**PLANNING AND ACCESS COMMITTEE**

| <b>APPLICATION NUMBER:</b> | <b>2017/0129/DET</b>                                          |
| <b>LOCATION:</b>           | <b>Land to rear of Tayview, Main Street, Killin, FK21 8UT</b> |
| <b>PROPOSAL:</b>           | <b>Erection of 1.5 storey dwellinghouse</b>                   |

**Figure 2. Site Plan**

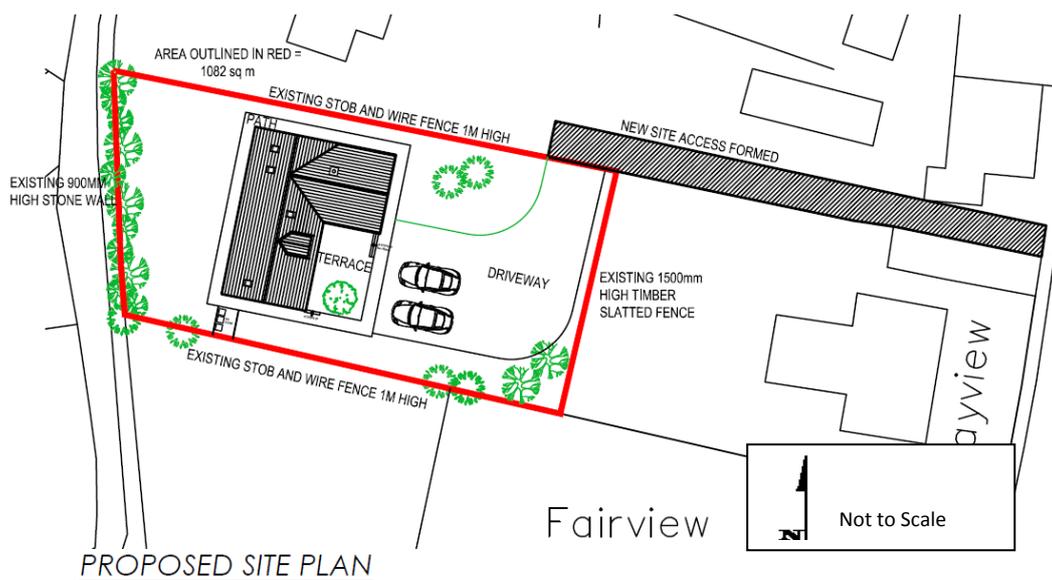
- 3.4 The proposal is for a 1.5 storey 3 bedroom detached house. Figure 2 shows the layout and shared access (hatched) alongside the shorter access (clear) to Tayview. There is no physical separation between the two accesses.
